GWF Henrietta Combined-Cycle Power Plant

Data Responses Set 1
(Responses to Data Requests 1 through 11)
GWF Henrietta Peaker Plant (01-AFC-18)

**Subject: Data Responses Set 1 (Responses to Data Requests 1 through 11
GWF Henrietta Combined Cycle Power Plant Project (01-AFC-18C))**

FIGURE DR2-1
GWF HENRIETTA COMPONENTS REQUIRING EXCAVATION GREATER THAN FOUR FEET IN DEPTH
 GWF HENRIETTA COMBINED-CYCLE POWER PLANT
 KINGS COUNTY, CALIFORNIA

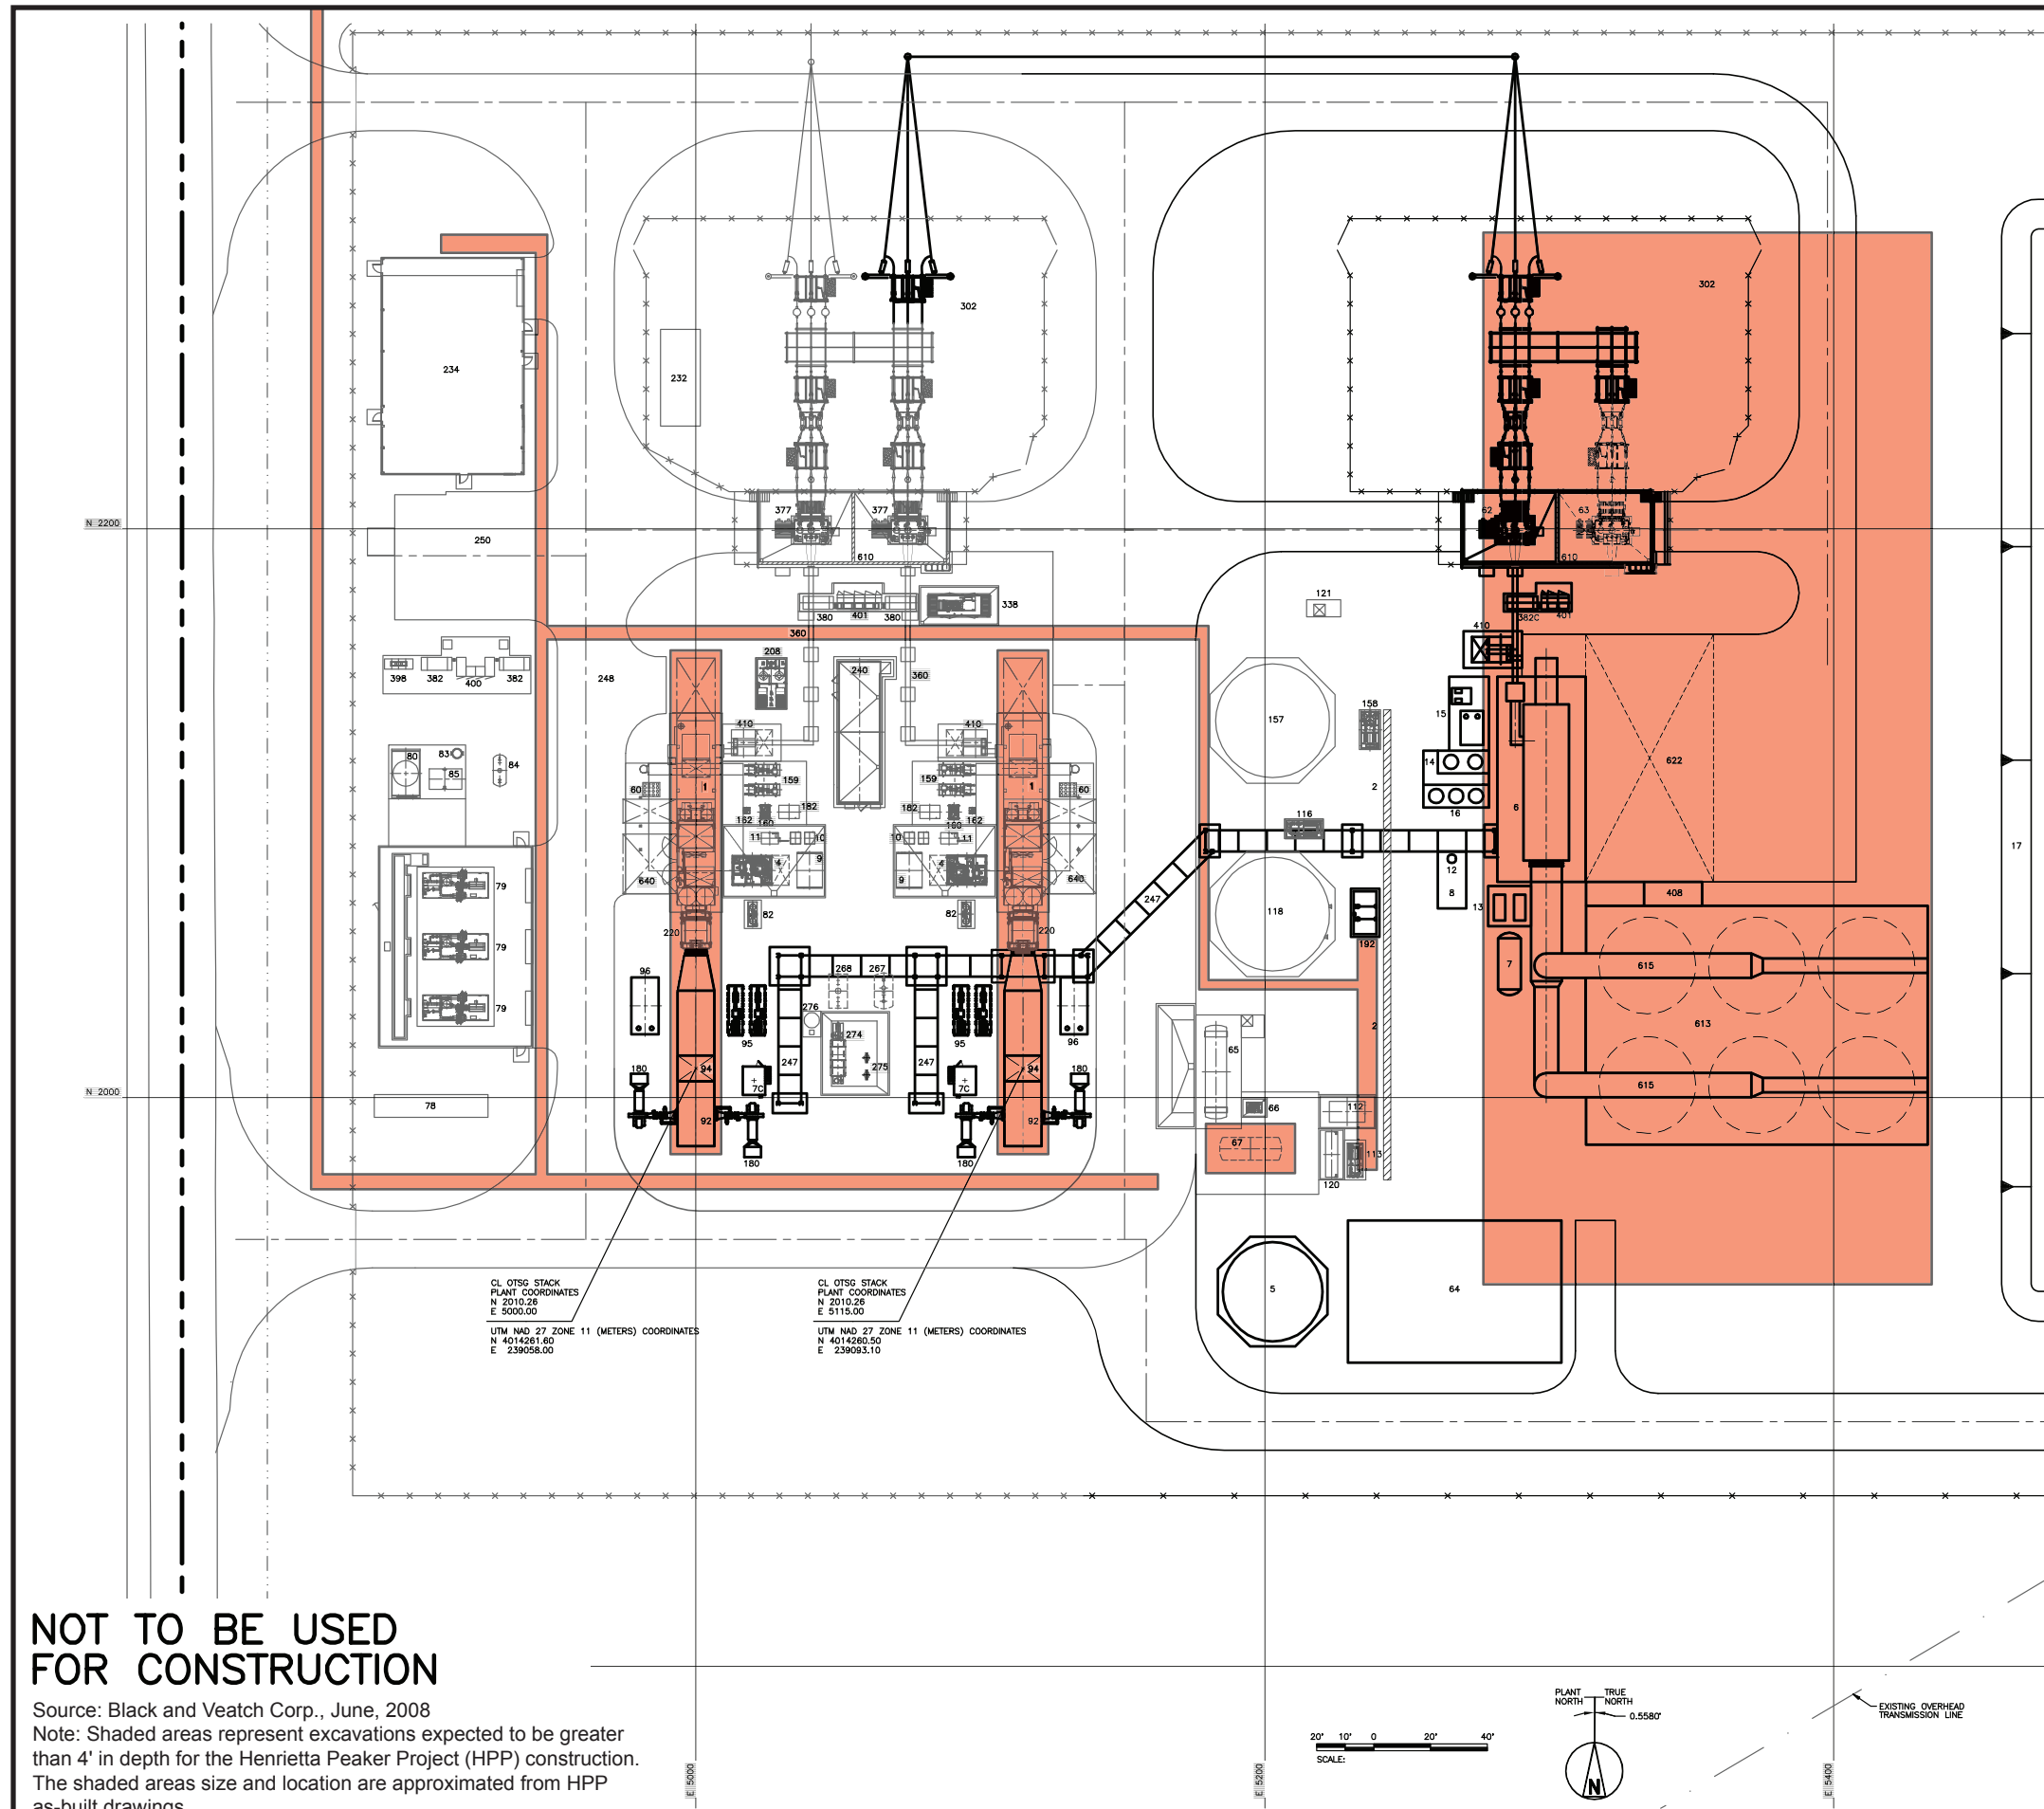
- Please provide a project site plan showing the locations of proposed equipment, pipelines, and underground tank installations the excavations for which would exceed 4 feet below the existing finish grade. A site plan such as Petition Figure 2-1 with the appropriate equipment and pipelines indicated by shading or other such convention would be acceptable.

Response: Please refer to attached Figure DR2-1. The shaded areas represent excavations expected to be greater than four feet in depth.

The existing HPP includes a storm water retention basin that is 6.5 feet deep on the eastern side of the plant, and as shown in Figure DR3-1, the majority of the new equipment will be constructed over the existing basin. The STG foundation will be elevated approximately 1.5 feet above the bottom of the existing retention basin and the ACC foundation will require excavation of an extra 6 inches from the bottom of the existing basin. Extensions of the fire protection system piping will require some additional trenching at depths greater than 4 feet, but the overall area is minimal. The installation of the existing ammonia spill tank at HPP required an excavation approximately 15 feet deep.

**FIGURE DR9-1
CONCEPTUAL ONE-LINE DIAGRAM OF THE
HENRIETTA SUBSTATION 70-KV BUS AFTER
INTERCONNECTION OF THE MODIFIED PROJECT**
GWF HENRIETTA COMBINED-CYCLE POWER PLANT
KINGS COUNTY, CALIFORNIA

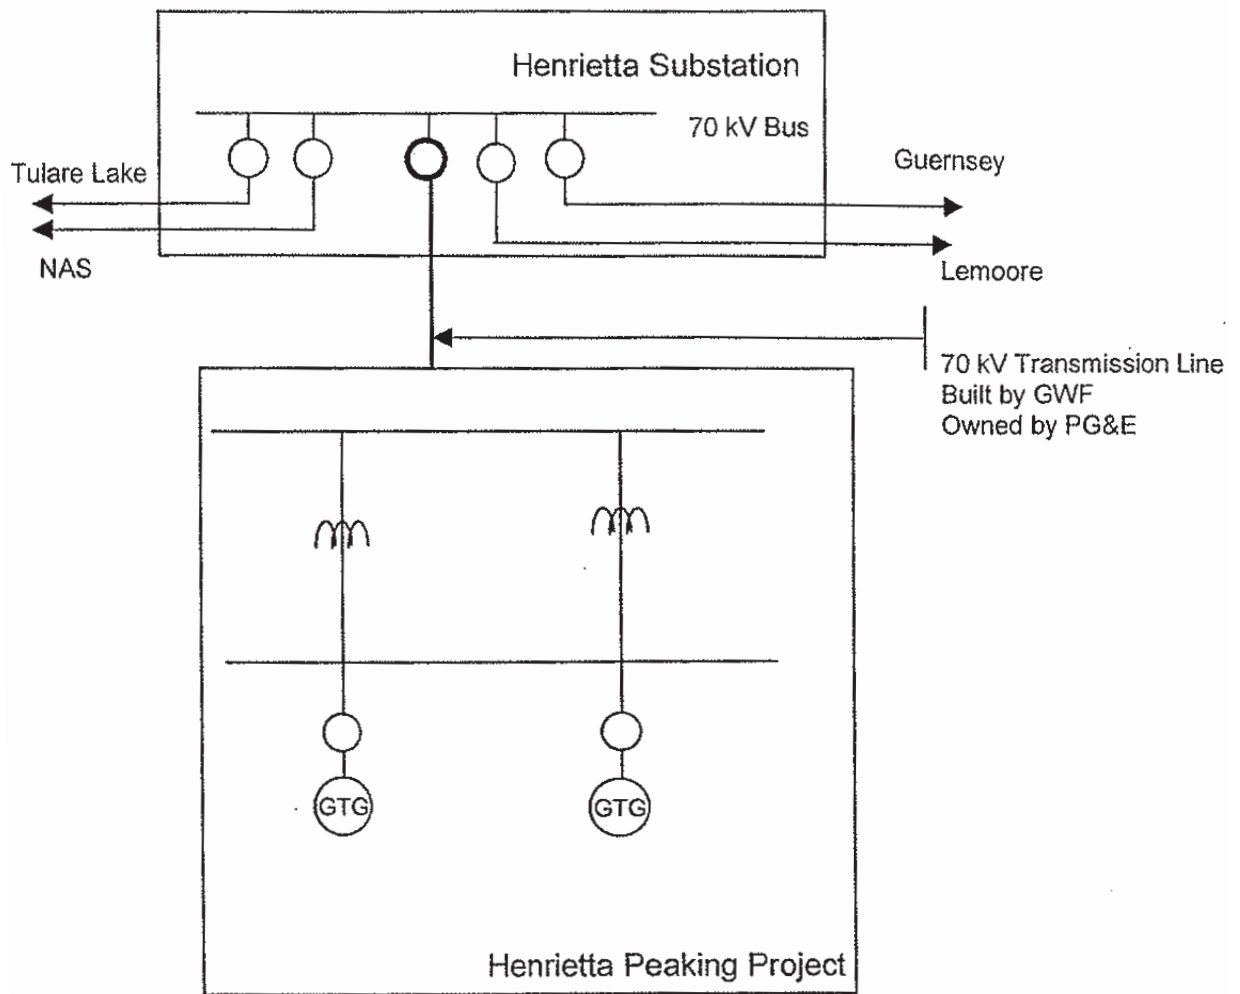
9. Provide a one-line diagram for the existing PG&E 70 kV Henrietta Substation after interconnection of the modified project. Show the existing bay arrangement of the equipments with ratings such as breakers, disconnect switches and relays, etc. which are required to interconnect the project.

Response: The SIS shows that no modifications in PG&E's 70-kV Henrietta Substation are required to accommodate the additional power generated from the STG. Attached Figure DR9-1 is a conceptual single-line diagram of the Henrietta Substation 70-kV bus where the plant interconnects.

FIGURE DR10-2
KEY OBSERVATION POINTS AND
ADDITIONAL VIEWPOINTS
 GWF HENRIETTA COMBINED-CYCLE POWER PLANT
 KINGS COUNTY, CALIFORNIA

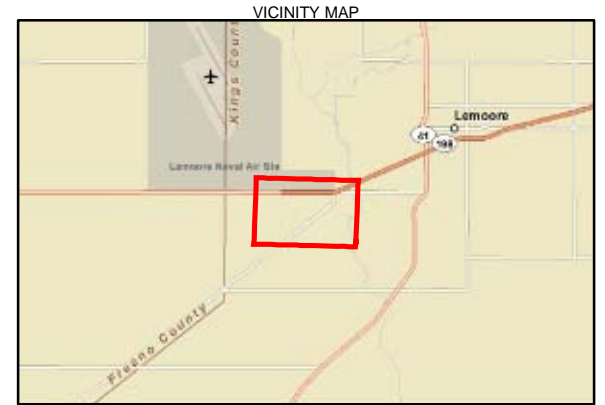
10. Please provide full-page color photographic reproductions of the existing site, including expansions. Please clearly identify all expansion areas as to their use; for example, construction, laydown, and parking.

Response: Consistent with your request and following coordination with CEC staff, this response addresses CEC staff concerns related to the visibility of temporary construction and laydown areas for GWF Henrietta. Figure DR10-1 shows the disturbed areas associated with GWF Henrietta and specifically identifies the construction laydown and parking areas. Figure DR10-2 shows the locations of the key observation points (KOP) presented in the Visual Resources Section of the GWF Henrietta License Amendment and one additional view point used to respond to this request (View DR10-3). Figure DR10-3 shows the extent of the construction laydown and parking areas, as viewed along 25th Avenue, zoomed in at 200%. Figure DR10-4A shows a closer view along 25th Avenue with the construction laydown and parking areas highlighted. Figure DR10-4B shows the location of the construction laydown and parking areas from a view to the south-southeast along 25th Avenue, north of the project site.
